To: Charlie Cazier, PE
From: Pat O'Mahony, Associate Planner; 910-341-0189
CC: File;
Date: 11/22/2021
Re: H2 Turbo Wash West TRC Rev. 1

Project Name: H2 Turbo Wash West
Formal TRC Date: 11/24/2021
Reviewer: Eric Seidel, PE
Department: Engineering – Plan Review Section

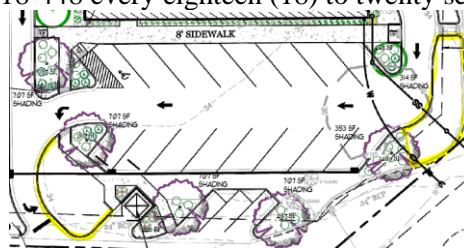
- Additional plantings shall be provided to achieve an opaque screen for the payment station, located on the northwestern side of the vehicle wash building, and for the entrance bay door, located on the southwestern side of the vehicle wash building, to screen from the Independence Boulevard and Carolina Beach Road rights-of-way. Please shown compliance with screening in the areas highlighted below:

Architectural Detail
Along Shopping Center
Entry Drive

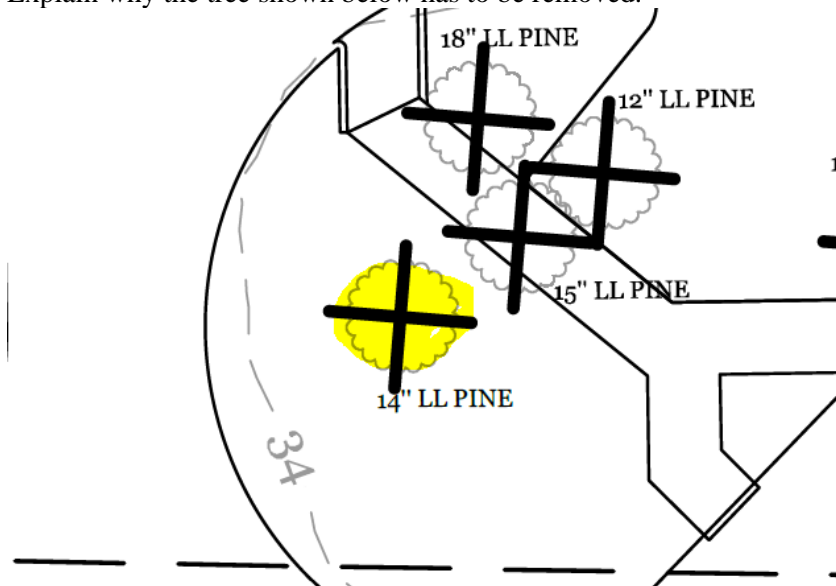
- Elevations shall be consistent with those provided and approved by City Council. Glazing was shown on the exterior of the building, but none shown on the submitted plans.
